Amendments to the Drawings

Remarks/Arguments

FIG. 5
PRIOR ART

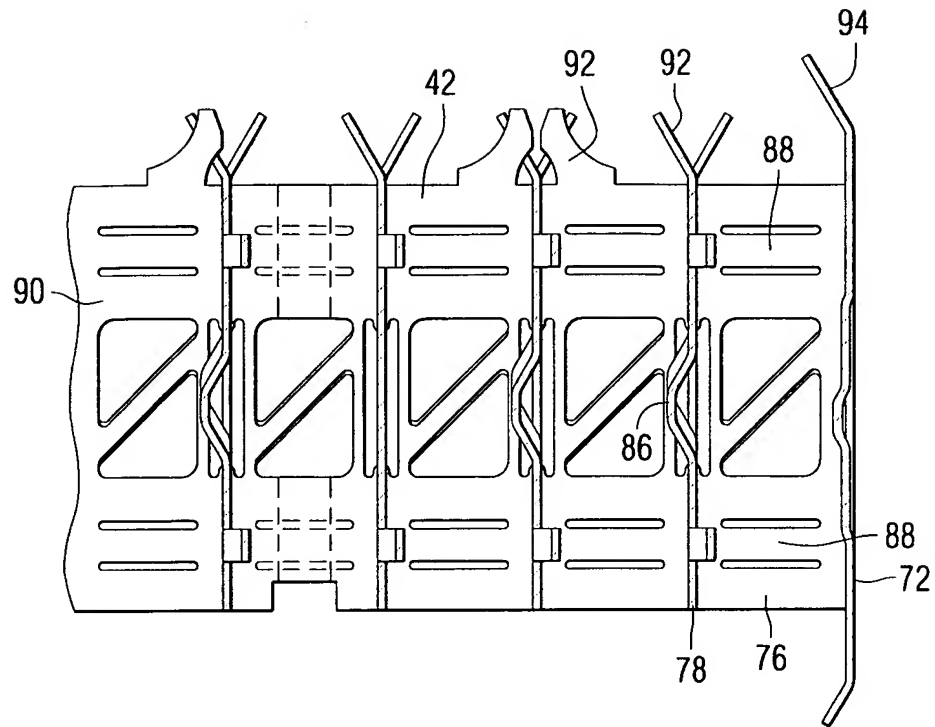
The attached sheet of drawings includes changes to Figure 5. This sheet, which includes Figures 5 and 7, replaces the original sheet including Figures 5 and 7. In Figure 5 a "PRIOR ART" legend has been added.

In Section 4 of the Office Action Fig. 5 was objected to for not having a prior art legend. The enclosed amendment to Fig. 5 should cure that defect. Accordingly, it is respectfully requested that the objection to Fig. 5 be withdrawn.
